Service Bulletin

No 14 rev 3 2008-04-08

Non return valves for protection of air distributor CD Units.

Non return valve #137
16101

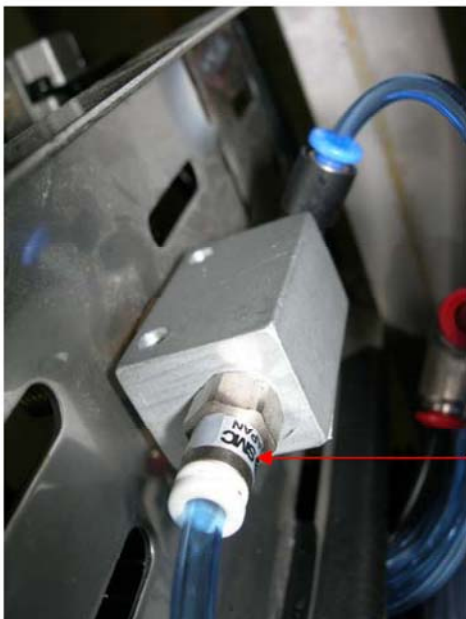
We have experienced damaged to the air distributor in the electric cabinet caused by water penetration on some vessels. This has been caused by leakage of the non return valve #137 on the circulation tank #52. See picture below:

In order to avoid and correct this problem Marinfloc recommend that the non-return valve is checked for leakage and replaced if necessary. Marinfloc also recommend that an extra non return valve is added to the hose after the air adjustment valve #136 for extra safety. See picture below:
